WLTP UNR Development (WLTP-28-09e)

Agreed proposals within WLTP Sub Group EV

Figure A8/2

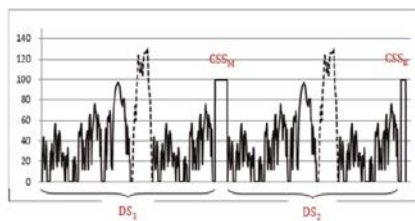
- Intention of the proposal:
 - In the referred paragraph, it is only described how to accelerate to reach the speed in the constant speed segment but it is not described how to decelerate
 - Proposal adds a sentence which also describes how to decelerate from constant speed to stand still
- Feedback:
 - JPN supports the proposal
 - EC supports the proposal
- Conclusion in IWG WLTP in Bern:
 - Including into UNR WLTP

The deceleration from the constant speed level shall be smooth and accomplished within 1 minute after completion of the constant speed segments.

| <input checked="" type="checkbox"/> | Supported and shall go into UNR WLTP first edition |
